ADMINISTRATIVE AMENDMENT

Classrooms and Gathering Hall

CHURCH of the RISEN SAVIOR

Risen Savior Addition
and Renovation

SITE PLAN
1 of 2

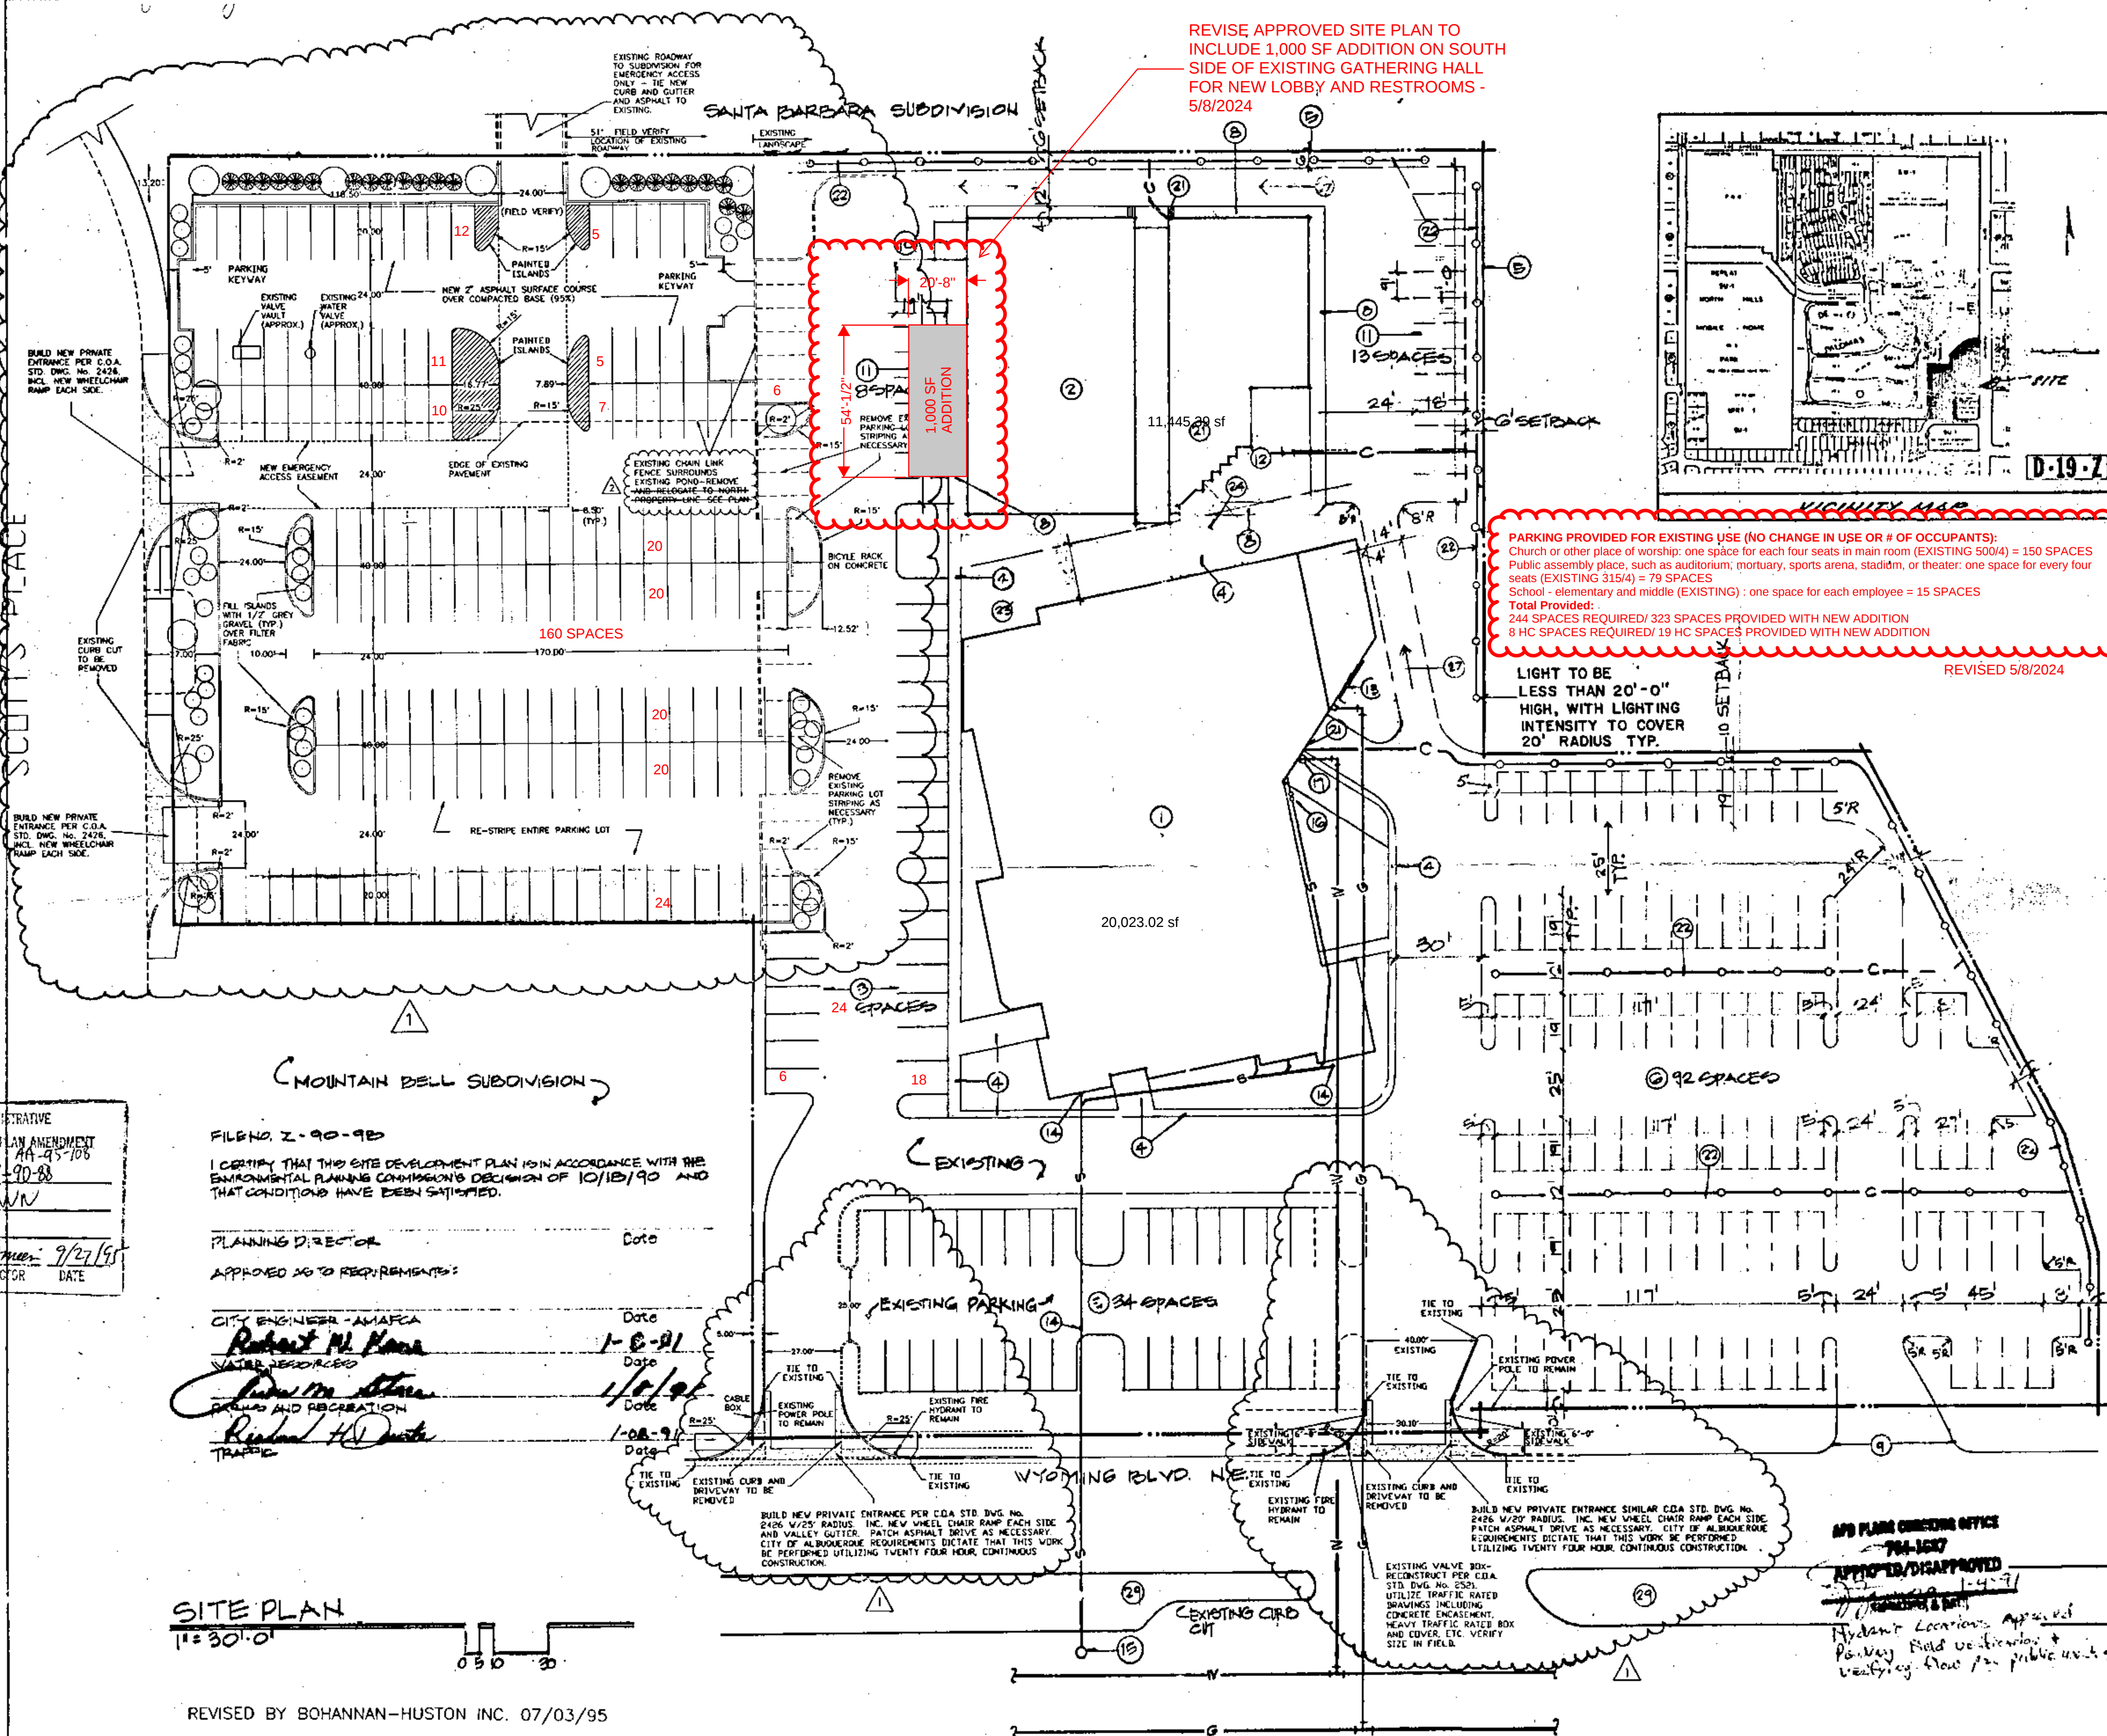
REVISE APPROVED SITE PLAN TO INCLUDE 1,000 SF ADDITION ON SOUTH SIDE OF EXISTING GATHERING HALL FOR NEW LOBBY AND RESTROOMS - 5/8/2024

REVISIONS
REVIS SOUTH PARKING LOT
REVIS MAIN ENTRY
ADD PARKING NORTHWESTERN AREA
ADD FENCE TO NORTH PROPERTY LINE

PARKING PROVIDED FOR EXISTING USE (NO CHANGE IN USE OR # OF OCCUPANTS): Church or other place of worship: one space for each four seats in main room (EXISTING 500/4) = 150 SPACES Public assembly place, such as auditorium, mortuary, sports arena, stadium, or theater: one space for every four seats (EXISTING 315/4) = 79 SPACES
Total Provided: 244 SPACES REQUIRED/ 323 SPACES PROVIDED WITH NEW ADDITION 8 HC SPACES REQUIRED/ 19 HC SPACES PROVIDED WITH NEW ADDITION
